PETITION NUMBER:	0810-VS-14
SUBJECT SITE ADDRESS:	304 W. Main Street
APPELLANT:	Thornberry Real Estate
REQUESTS:	The Appellant is requesting a Variance of Standard from the following Westfield-Washington Zoning Ordinance sections: 1. **WC 16.04.070, 4** (to reduce the minimum lot size in the US 31 Overlay District from 5 acres to 0.39 acre) 2. **WC 16.04.070, 5c** (to reduce the front yard setback in the US 31 Overlay District from 60 feet to 20 feet) 3. **WC 16.04.070, 5d** (to reduce the side yard setback in the US 31 Overlay District from 45 feet to 10 feet on the east and 18 feet, 8 inches on the west) 4. **WC 16.04.070, 5f** (to reduce the minimum aggregate of side yard in the US 31 Overlay District from 90 feet to 28 feet, 8 inches) 5. **WC 16.04.070, 5g** (to reduce the minimum lot width in the US 31 Overlay District from half the depth of the lot (229.5 feet) to 73.66 feet) 6. **WC 16.04.070, 5h** (to reduce the minimum aggregate gross floor area in the US 31 Overlay District from 15,000 square feet to 4,050 square feet) 7. **WC 16.04.070, 8** (to vary the following US 31 Overlay building materials requirements for all facades): o To reduce number of building materials from

SITE PLAN 1/8"=1'-0"

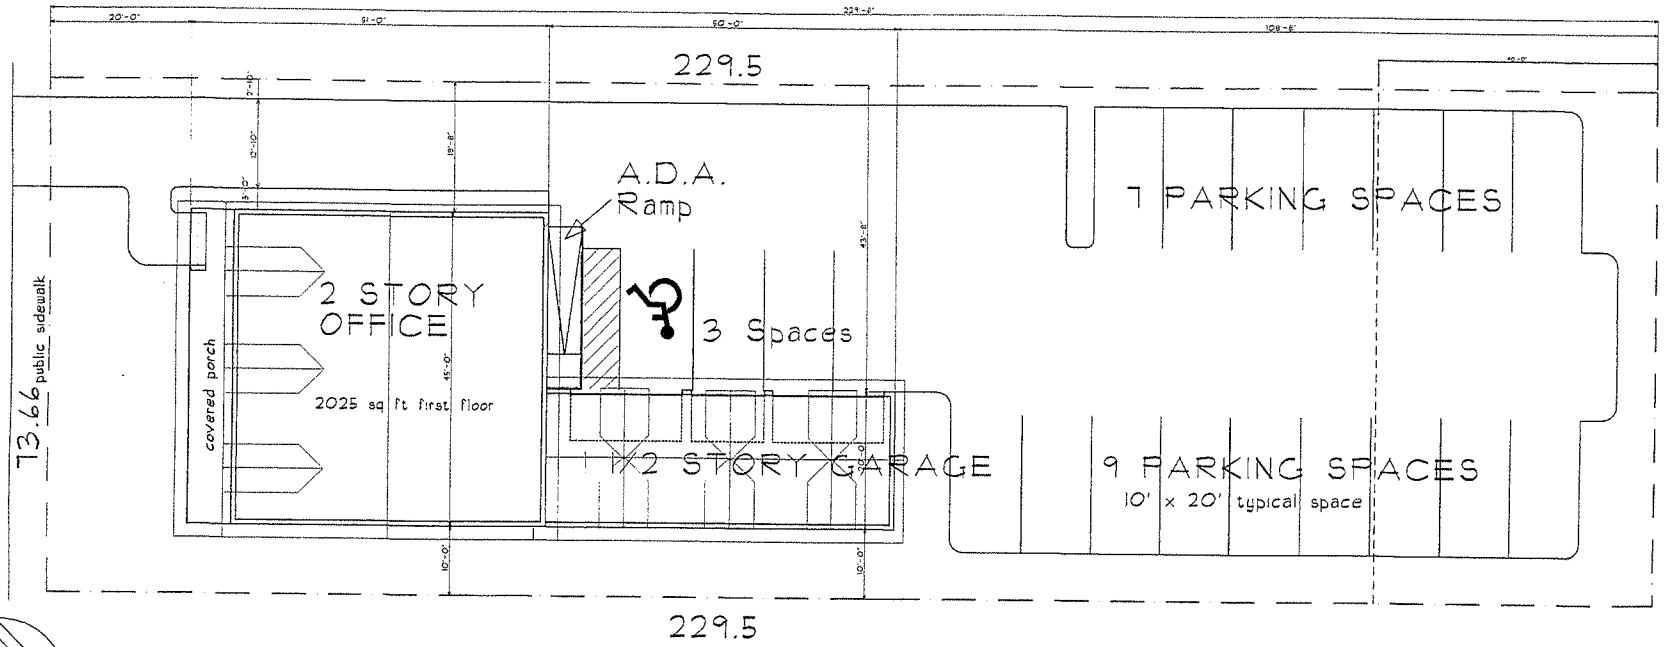
1) 503.2.5 Dead Ends - Dead end apparatus access roads in excess of 150 feet in length shall be provided with an approved area for turning around fire apparatus.

> - As this project is submitted, the parking lot from State Road 32 is in excess of 229 feet. The end of the parking lot is an area that has 16 parking spaces. There is no room within this area for any fire department apparatus to turn around and it exceeds the 150 feet set forth by the Indiana Fire Prevention Code.

2) 503.2.1 Dimensions - Fire apparatus access roads shall have an unobstructed width of not less than 20 feet except for approved security gates in accordance with Section 503.6 and an unobstructed vertical clearance of not less than 13 feet 6 inches.

> - As this project is submitted, the access road from State Road 32 to the parking lot in the rear of the structure is designed at 12 feet 10 inches. This does not meet the required width set forth by the Indiana Fire Prevention Code.

3) 503.1.1 - Buildings and facilities - Approved fire apparatus access roads shall be provided for every facility, building or portion of a building hereafter constructed or moved into or within the jurisdiction. The fire apparatus access road shall comply with the requirements of this section and shall extend to within 150 feet (45 720 mm) of all portions of the facility or any portion of the exterior wall of the first story of the building as measured by an approved route around the exterior of the building or facility.

- The proposed building has the building that the East side of the structure exceeding the 150 feet for fire suppression. There is no access to this side of the structure and plans do not show that the building will be protected by an automatic sprinkler system. This does exceed the rule and is not permitted by the Indiana Fire Prevention Code.

Additionally, the proposed project calls for parking to be placed in front of the parking garage which will block access to the building or any vehicle parked in the garage. In the event of a car fire within the garage will be hindered by the parking in front of the garage.
